Watts Bar Nuclear Plant, Unit 2
NRC Docket No. 50-391

Subject: Watts Bar Nuclear Plant (WBN) Unit 2 - Response to Generic Letter (GL) 2004-02, Potential Impact of Debris Blockage on Emergency Recirculation During Design Basis Accidents at Pressurized-Water Reactors

Supplemental Response to Address GL 2004-02 Actions at Unit 2 Using Revised Content Guide for GL 2004-02 Supplemental Responses

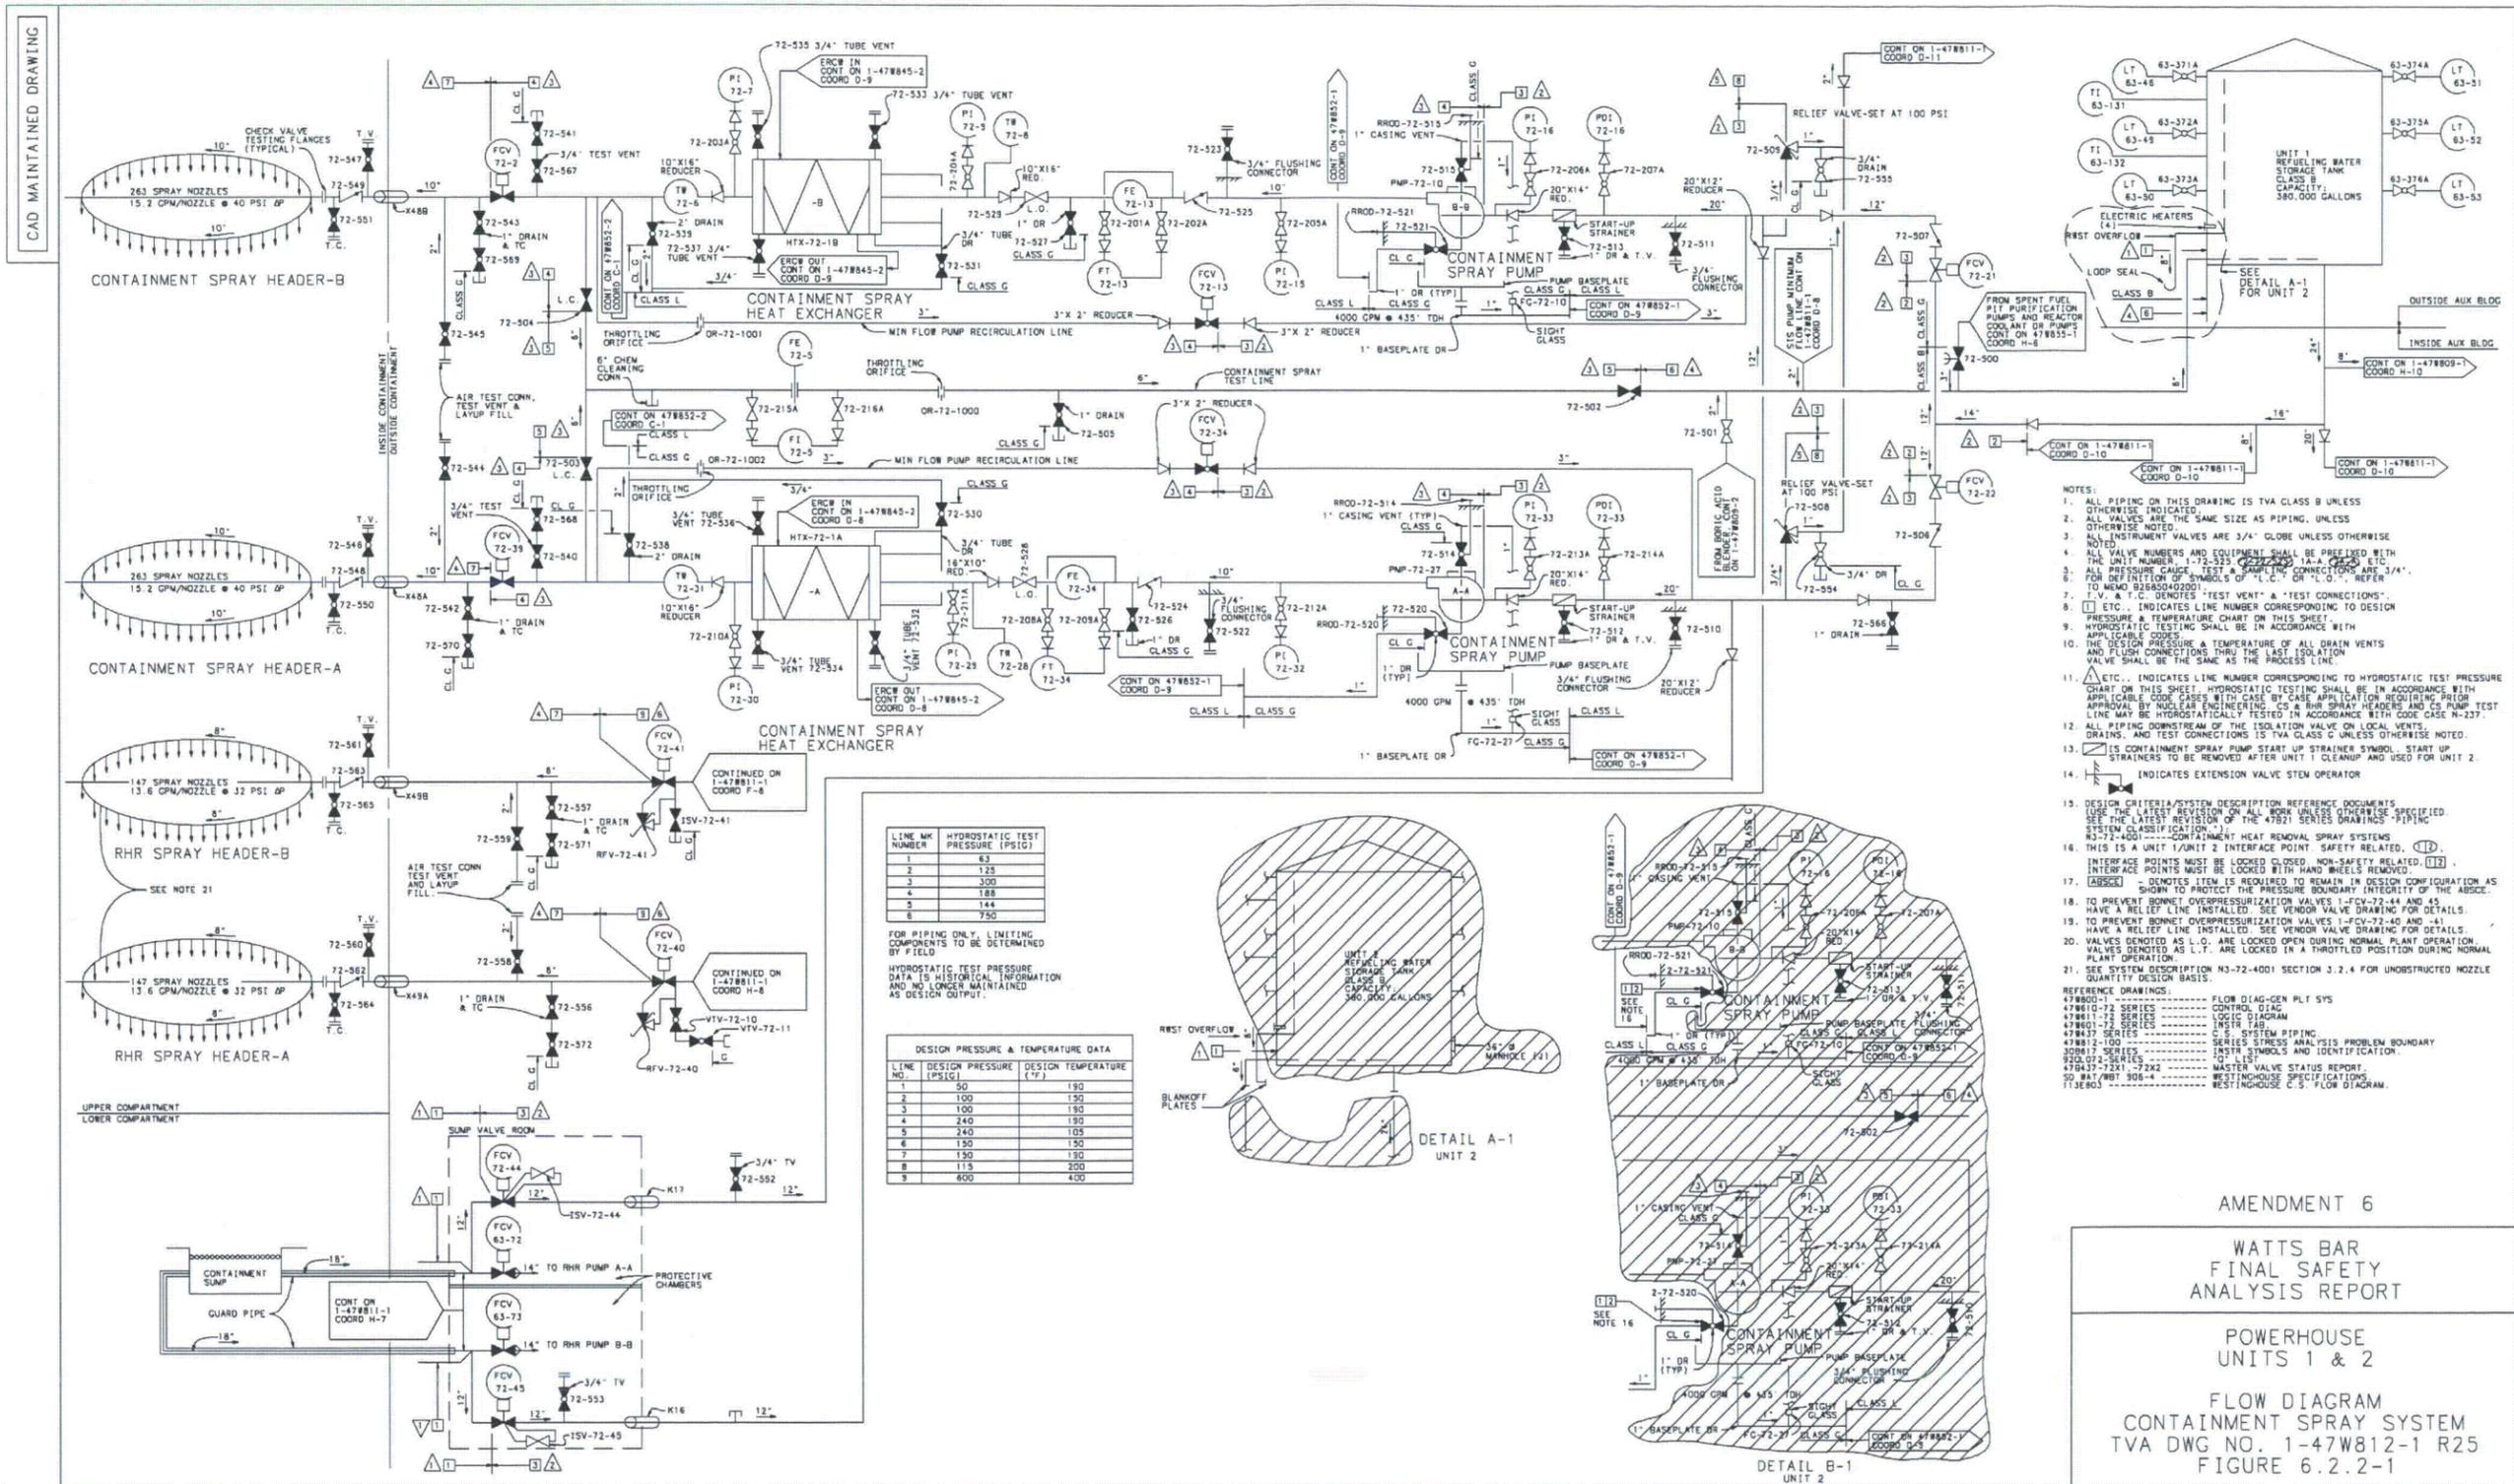
- 3.f.1.** *Provide a schematic diagram of the emergency core cooling system (ECCS) and containment spray systems (CSS).*

Figures 6.2.2-1 and 6.3-1-1 of the Unit 1 Updated Final Safety Analysis Report (UFSAR) provide schematic flow diagrams for CSS and ECCS, respectively. (Copies are provided herein for convenience.) Unit 2 design/construction is in progress but will be functionally the same as Unit 1.

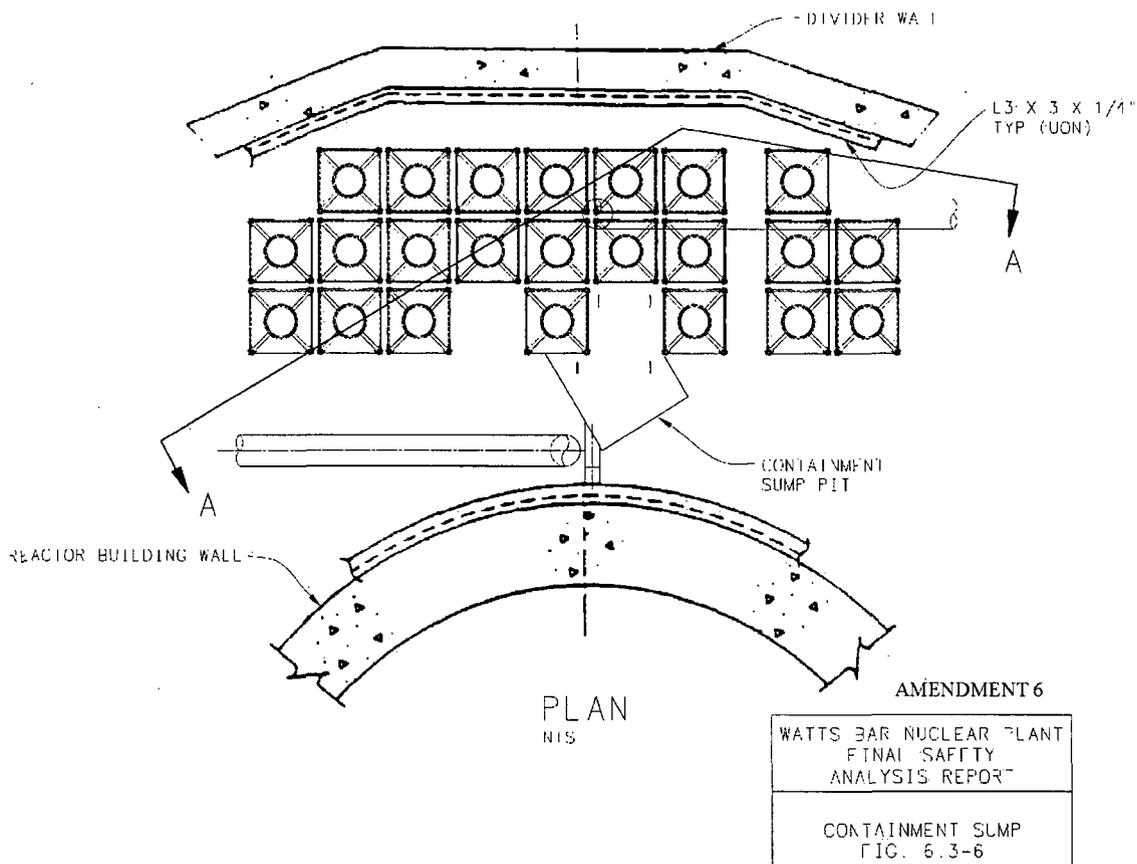
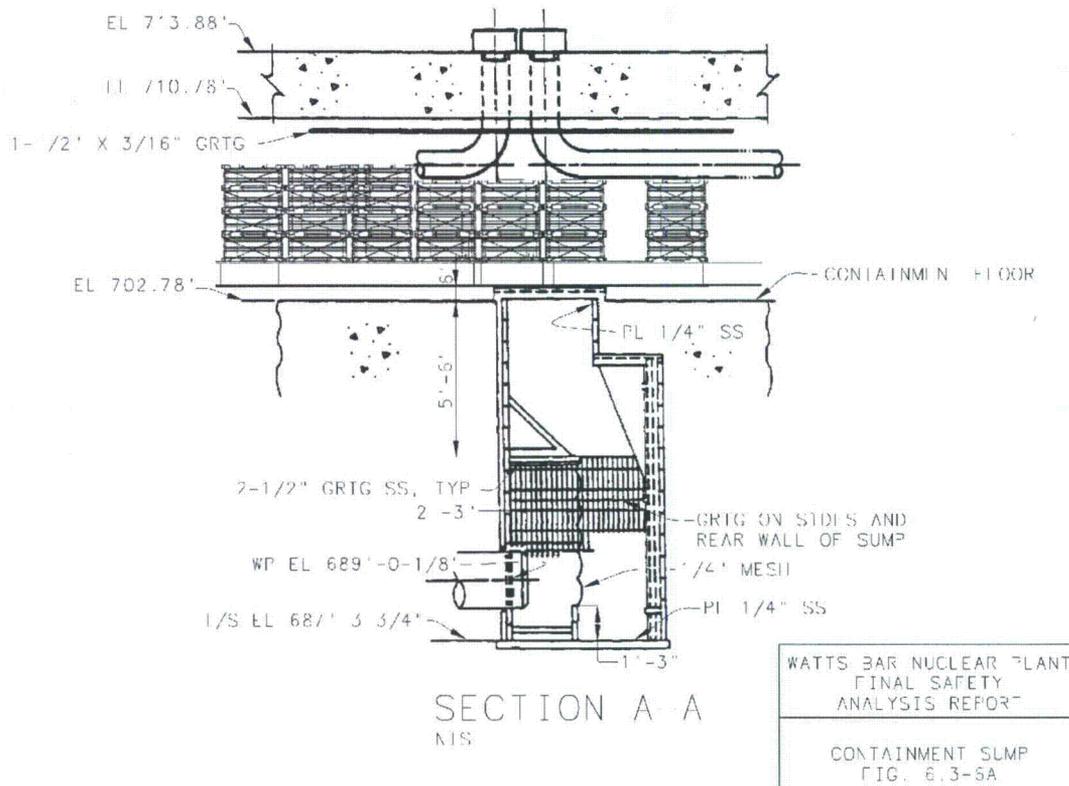
- 3.k.3.** Summarize the evaluations performed for dynamic effects such as pipe whip, jet impingement, and missile impacts associated with high-energy line breaks (as applicable).

The location of the WBN containment sump strainers was reviewed relative to the existing containment pipe break dynamic effects analysis. The strainers are located in a relatively protected location in the lower containment below the refueling cavity as shown in Unit 1 UFSAR Figures 6.3-6 and 6.3-6a (Figures are provided herein for convenience.). The review found that the location of the strainers was not subject to jet impingement, pipe whip or missile impacts from high energy line breaks inside containment. This evaluation is consistent with current WBN licensing basis which has deleted the dynamic effects of a primary system pipe break from consideration based on the application of leak-before-break criteria. As such, jet impingement, pipe whip and debris impact loads were not included in the strainer/plenum assembly structural analysis.
